ATTACHMENT TO LICENSE AMENDMENT

AMENDMENT NO. 36 TO FACILITY OPERATING LICENSE NO. DPR-43

DOCKET NO. 50-305

Revise Appendix A as follows:

Figure TS 3.10-7

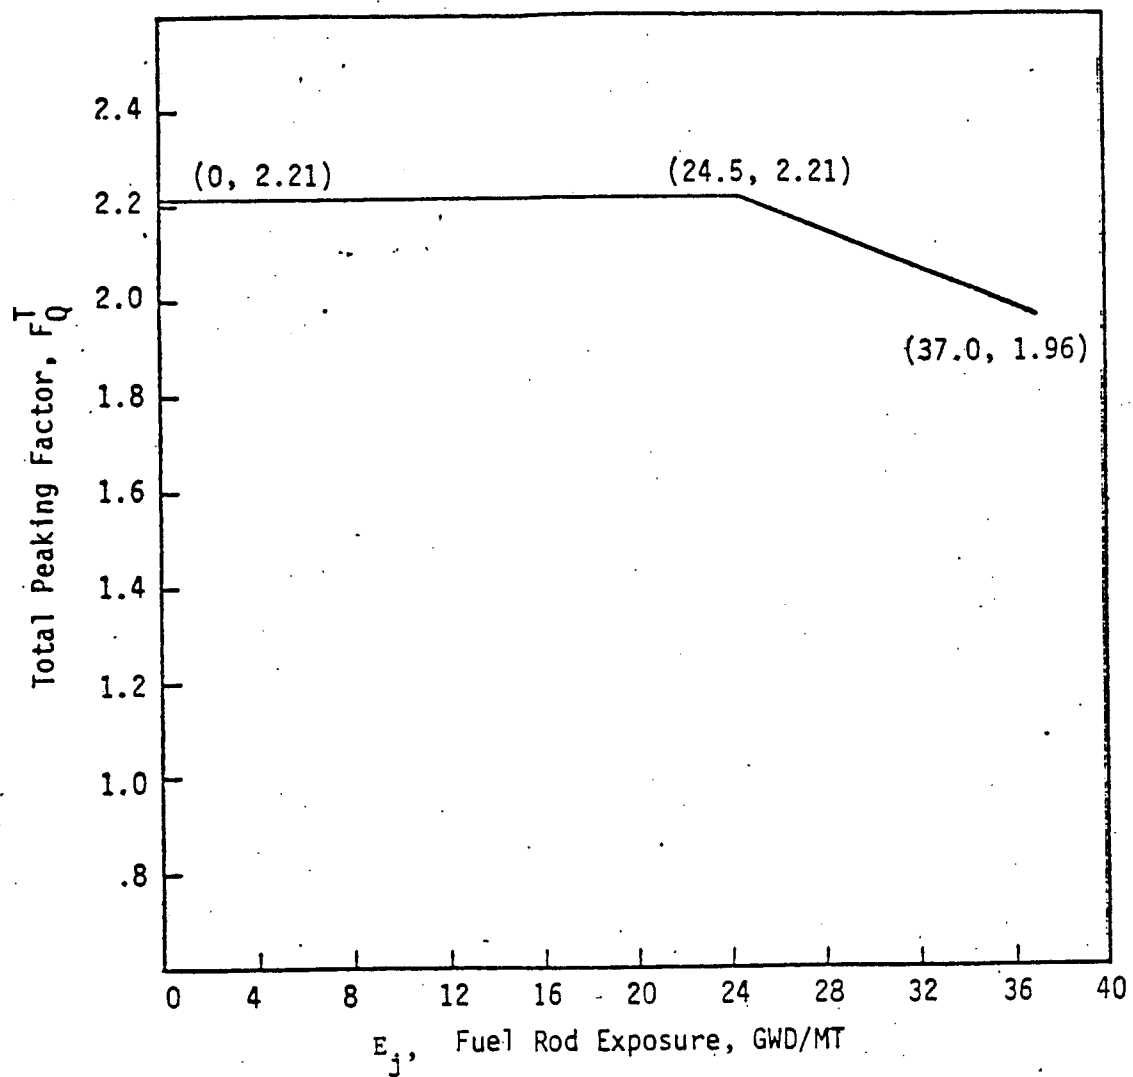
$F_Q^T(E_j)$ is the function given in Figure TS 3.10-7

The $F_Q(Z)$ limits of specification 3.10.b.1.a include consideration of enhanced fission gas release at high burn up, off-gassing (release of sorbed gases), and other effects in fuel supplied by Exxon Nuclear Company; this results in

an additional penalty in the form of the function $BU(E_j)$, as shown in Figure TS 3.10-7, which is applied to Exxon fuel. References 7 and 8 discuss these phenomena.

$$F_Q(Z) \leq F_Q^T(E_j) \times K(Z) \text{ for } P > .5$$
